The 12510 15th Avenue NE site is located along an active commercial corridor at the intersection of three neighborhoods: Pinehurst, Olympic Hills and Victory Heights. The project team seeks to design a multi-unit development with 5 ground level retail spaces, one live-work unit and 38 townhouse units. The small pedestrian oriented retail will enhance varied existing neighborhood context.

From our Second Recommendation Meeting on March 13, 2017, there were four main Priorities and Recommendations presented by the Board. The Design Team reviewed the pertinent Design Guidelines and reassessed the vision for the project. The following pages are the detailed recommendations and our responses and solutions to these items.

SECOND RECOMMENDATION MEETING - MARCH 13, 2017

VIEW ALONG 15TH AVE

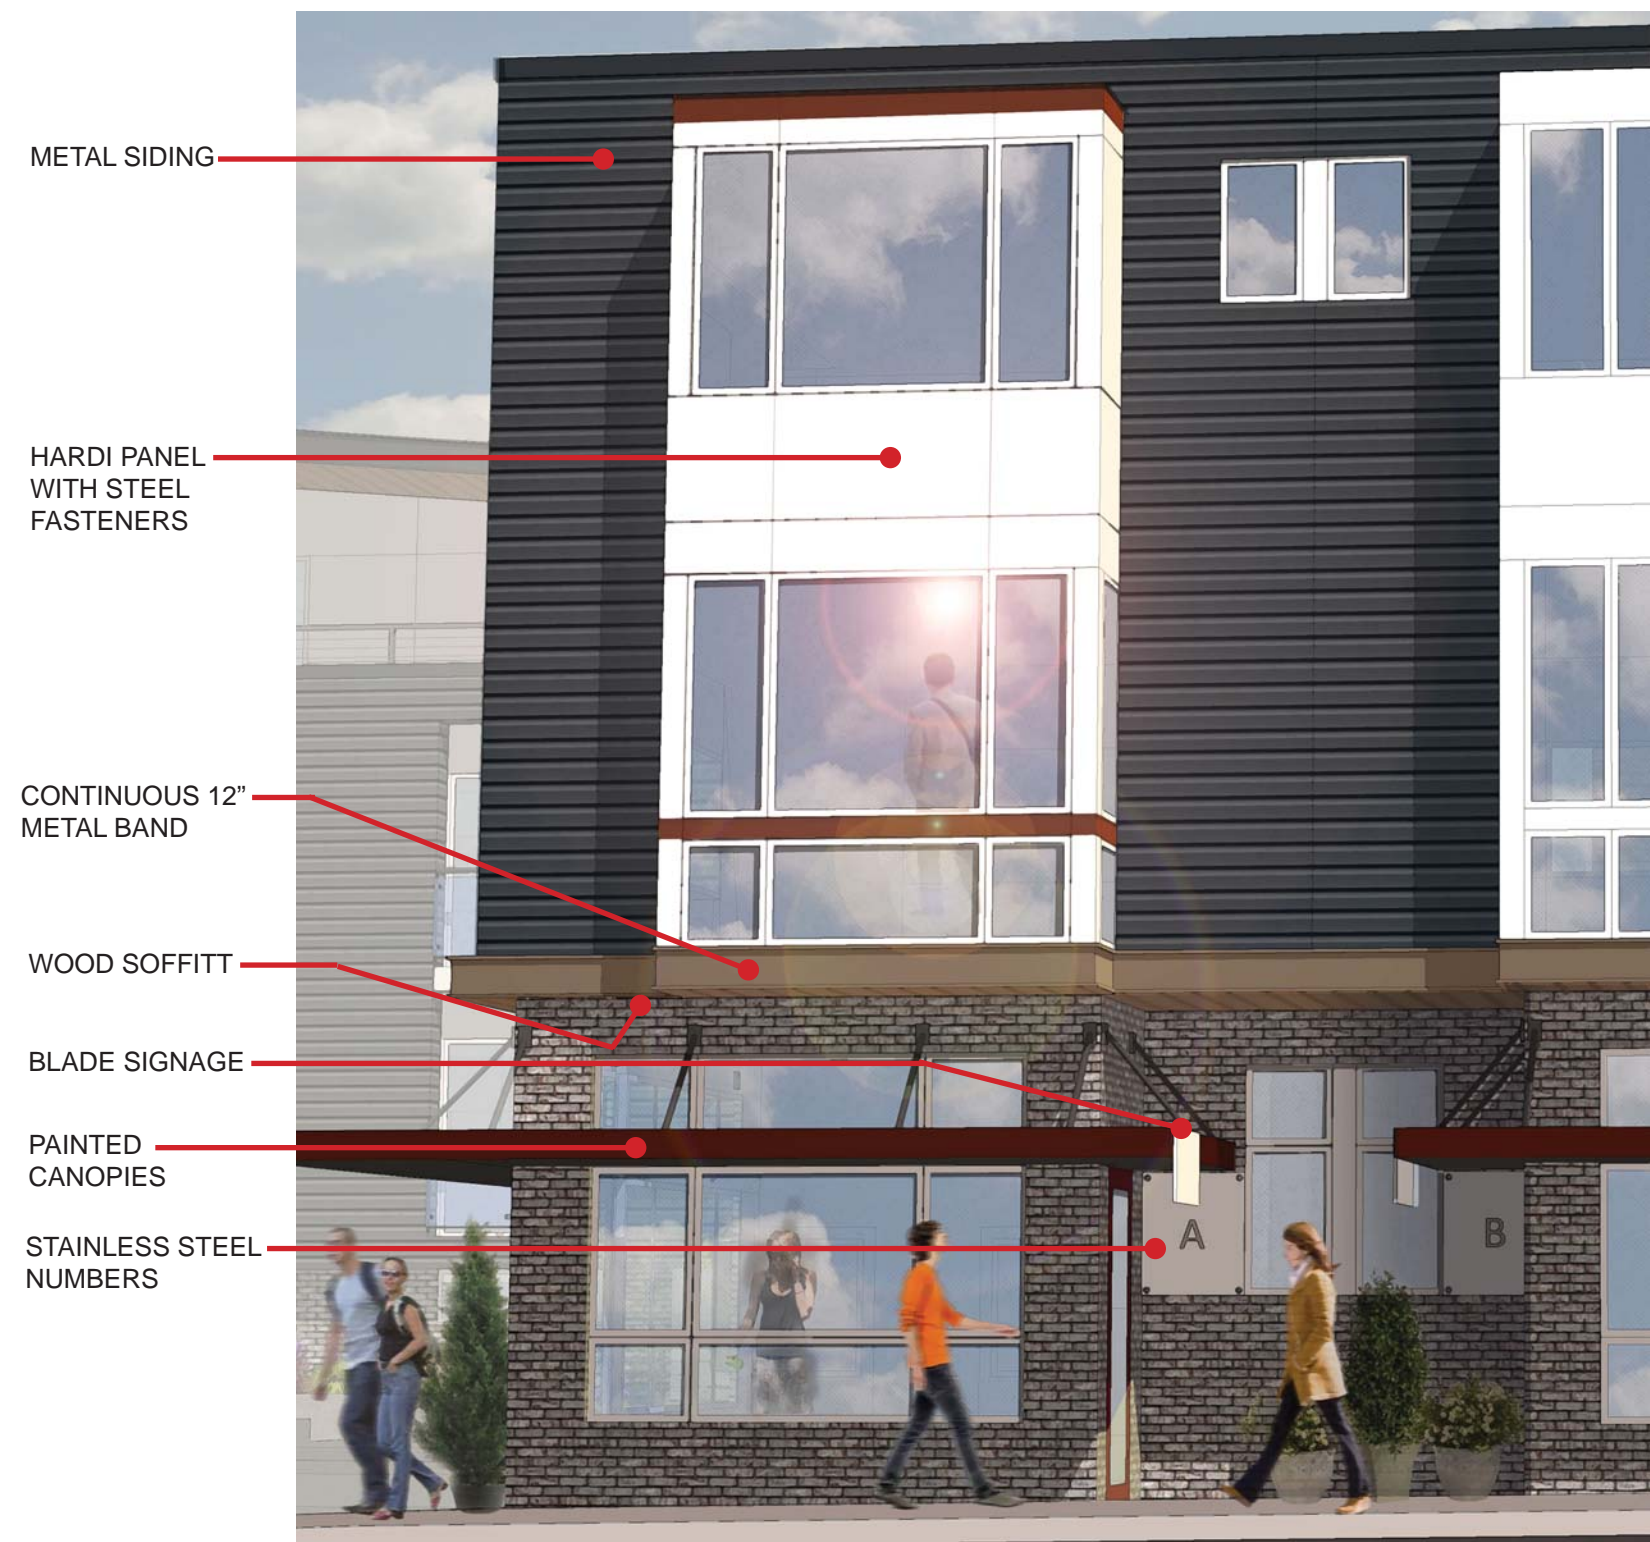
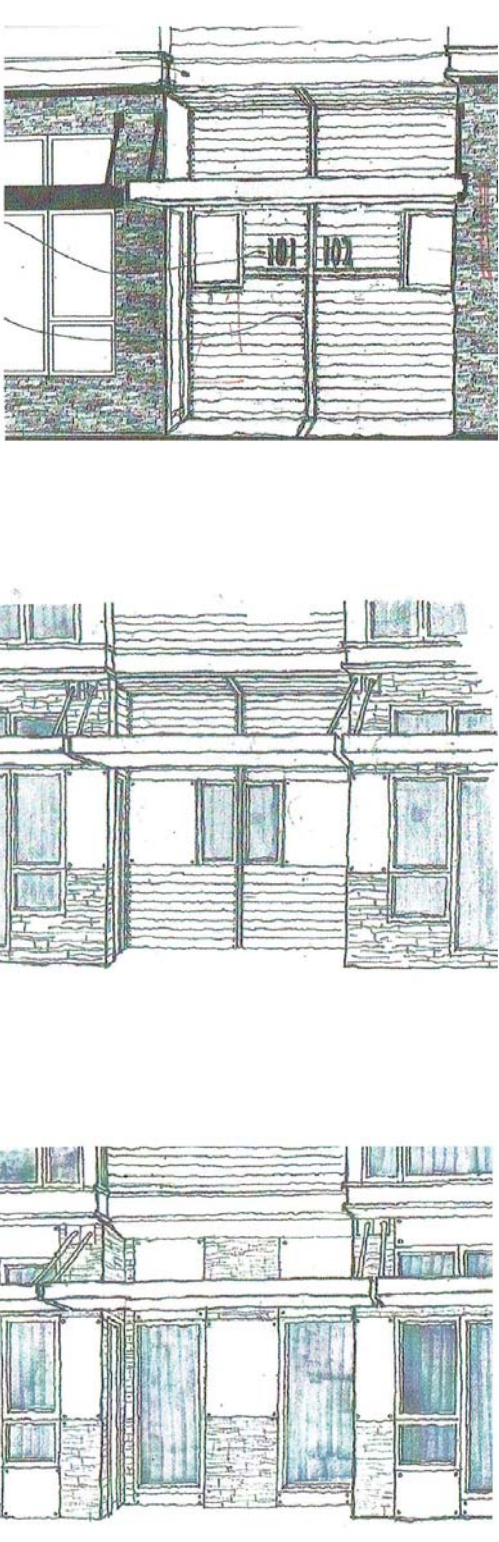
a. The Board expressed disappointment that the design of the west elevation of Building 10 did not respond to the Board's guidance provided at the first Recommendation meeting. The Board had asked that the elevation express a strong commercial character, and instead the proposed fiber cement products evoke a more suburban setting. At the second Recommendation meeting, the Board recommended use of higher quality materials that reflect a stronger urban edge/commercial character.

c. On the west elevations of Buildings 9 and 10 facing 15th Ave NE, a stone composite is proposed at ground level. This stone application is broken up with an alcove (at the space entrances) and is treated with what appears to be stained wood lap siding. The Board agreed this break in material application at ground level lacked cohesion and was not well integrated into the overall building design. The Board requested that additional detail be provided in the materials for the next meeting to clearly describe how the materials will join each other. Additionally, include larger scale images of the materials to include more detail than is shown in the second Recommendation packet.

Response: The fiber cement siding has been replaced with a high profile metal siding for above the commercial level. Brick for the entire commercial level is now being introduced to further emphasize urban and commercial character.

Response: The street level brick transitions to the upper level metal siding and Hardi-panel bay windows with a 12" continuous bent metal belly band as a common urban/street front material. Additional design changes include relocating and ganging together of the smaller alcove windows to provide a high visibility area for commercial addressing, larger retail windows along 15th street, and blade signage for every retail entry.

SECOND RECOMMENDATION RESPONSE DIAGRAM FOR URBAN GARDEN

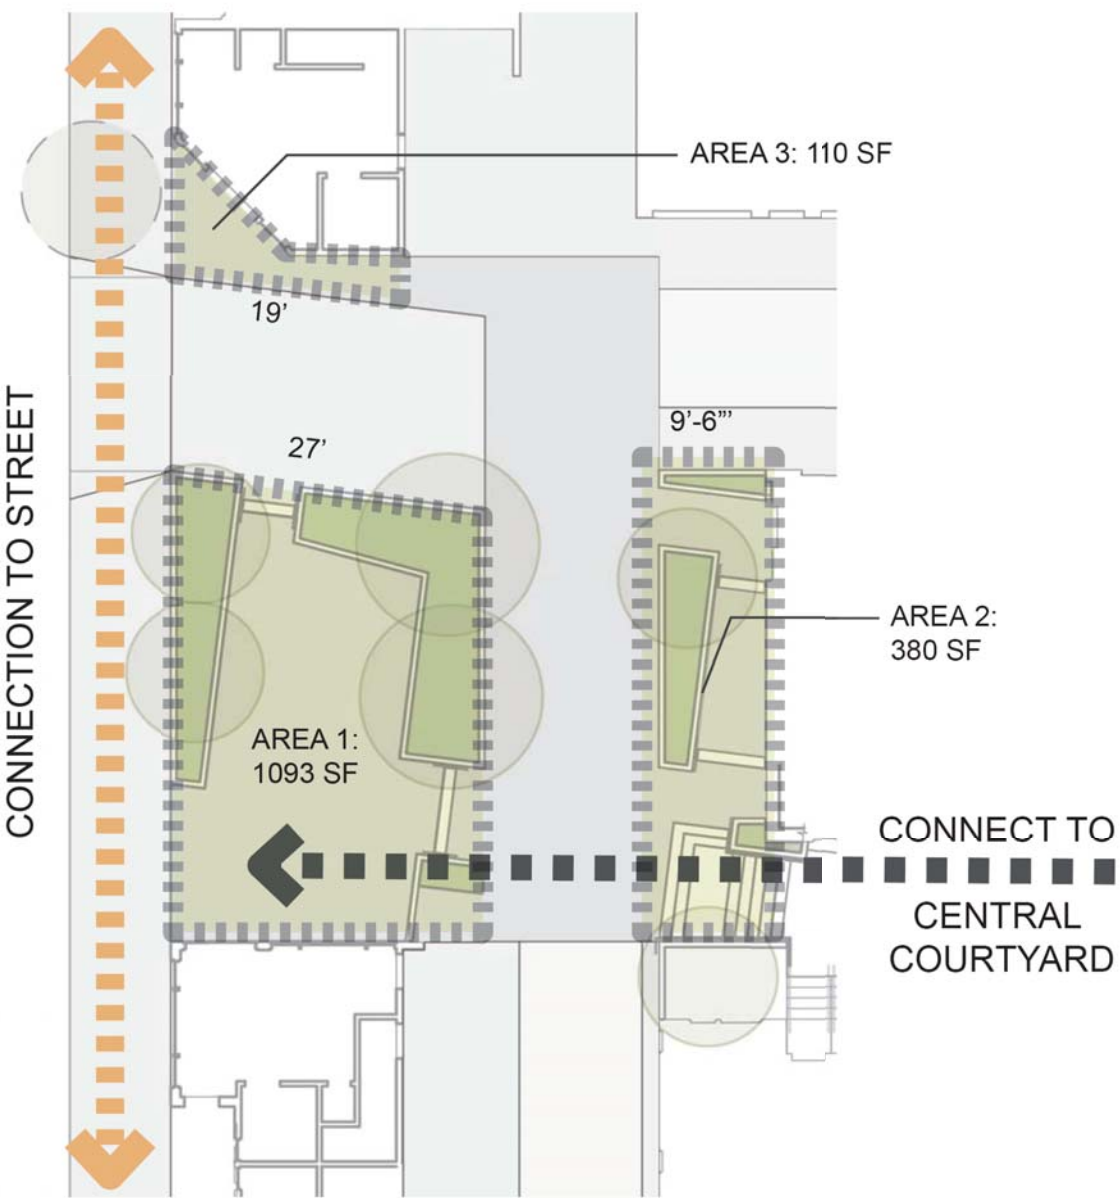
a. The north elevation of Building 10 faces the urban garden, and is treated with minimal transparency. The Board was not supportive of this treatment and lack of transparency, and recommended additional glazing on this north elevation be provided to promote greater connection between the interior and exterior spaces. Eyes on the urban garden should be a priority.

b. At the first Recommendation meeting, the Board provided guidance to increase the size of the urban garden by extending it east across the interior drive. Rather than increase the size of the garden, the applicant proposed a reduction to the required area by 133 square feet. The Board expressed disappointment with this proposal, finding no compelling reason how this design better meets the intent of the Design Guidelines and the Board's guidance.

c. In addition to the size of the urban garden, the design of the garden was also discussed. As described by the applicant, no permanent furniture is proposed. The Board agreed that activation of this space is a priority: it should be permeable, a usable amenity for the neighborhood, and less like a patio – more like usable open space.

RESPONSE: The elevation of Building 10 has been redesigned to engage the courtyard and include additional courtyard space directly associated with the building Live-Work Unit.

RESPONSE: As a result of removing a unit, the design has now extended the courtyard, meeting the code required open space square footage and includes activation of Building 10 as discussed above.

RESPONSE: Permanent seating has been provided per SMC 23.71.014 in the form of planter / seat walls equal to the 60 linear feet required.

CURRENT PROPOSAL - REVISED BUILDING 5

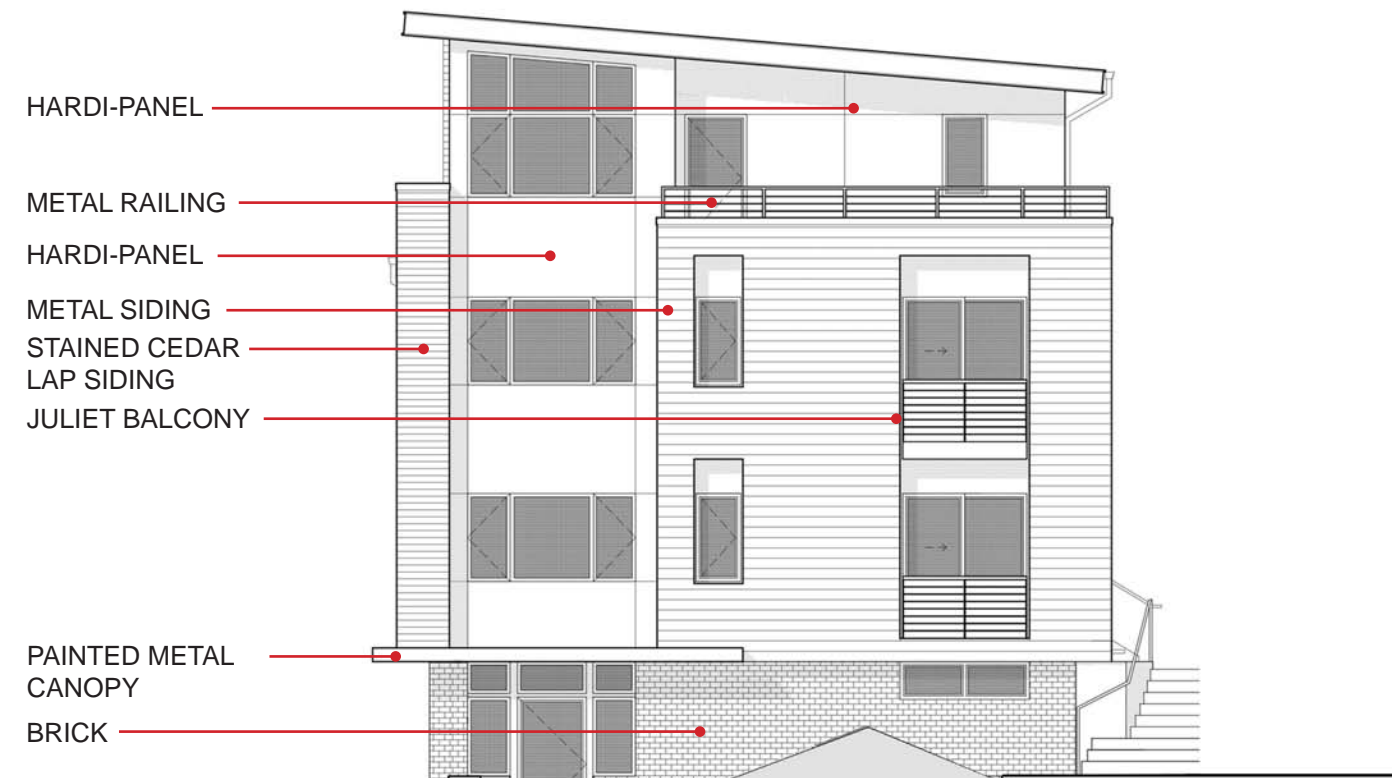
b. Furthermore, at the first Recommendation meeting, the Board asked the applicant to change the end (west) unit #10 within Building 5 (page 5, Recommendation Packet #2), from a townhouse unit to a residential use facing the urban garden and street. The project did not respond to this guidance. The Board expressed frustration with this programming, finding it to undermine the Code and design guidelines intent.

Response: Building 5 has been completely redesigned to not only provide more Entry Court/Urban Garden square footage, but it's façade has been completely redesigned with a street level entry facing 15th, a "this is the front door" tower like character for the Entry Court/Urban Garden, and a rooftop terrace overlooking the Entry Court/Urban Garden. Furthermore, every unit interacting/facing the courtyard has been given additional windows and balconies, on every level, to enhance the Entry Court/Urban Garden urbane character.

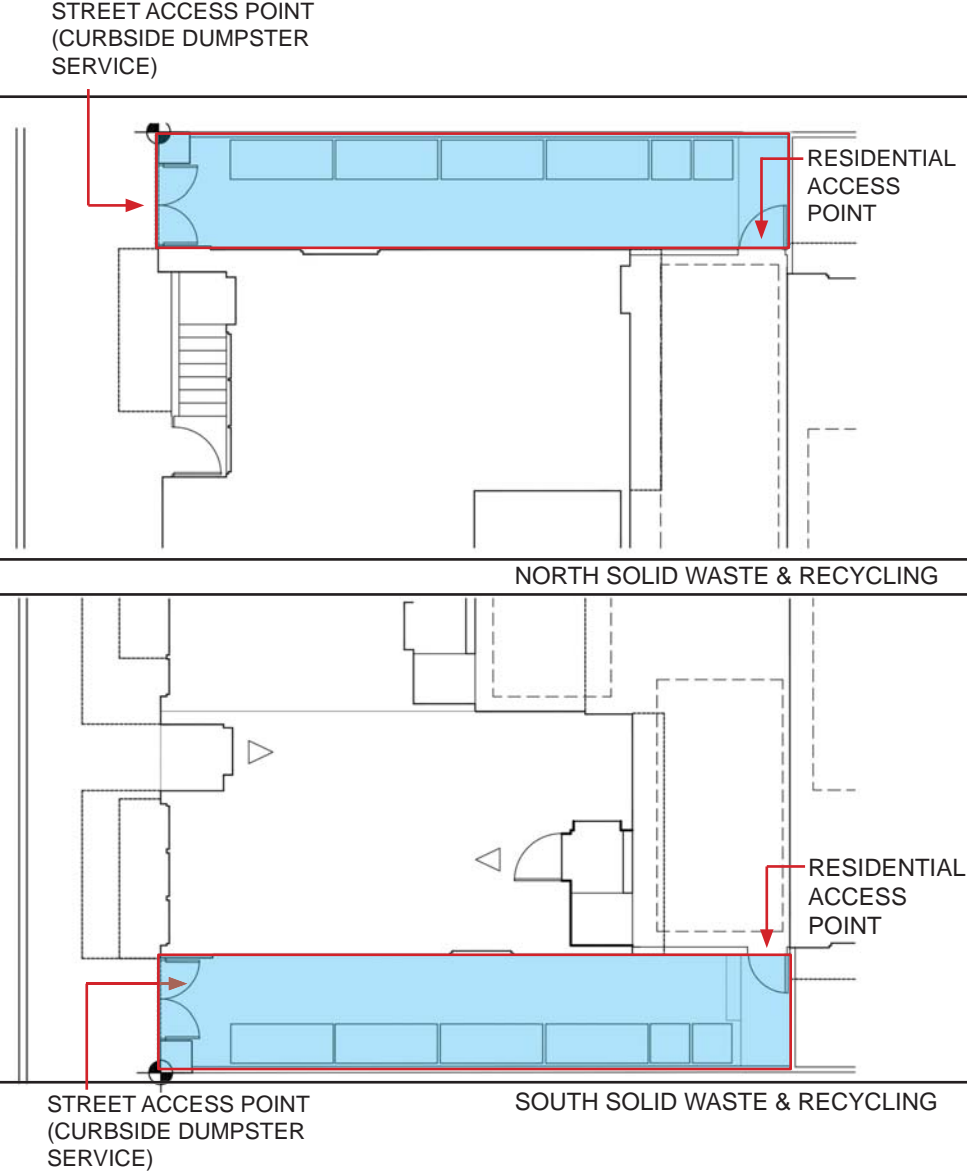
The storage of solid waste and recycling was proposed along the north and south property lines abutting 15th Ave NE. The Board supported these two locations, but requested additional detail describing the proposed screening and access to and through the areas. As shown in the second Recommendation packet, it appears access is provided only from the street. This was not supported by the Board as they would like to see access also provided from the interior of the site. Gates were also requested.

Response: The North and South solid waste and recycling areas have both residential and street access. Design of the street access for the two areas has been incorporated into the character of the commercial buildings with gates of metal siding, a continuation of the canopies with a metal channel header, and piers of
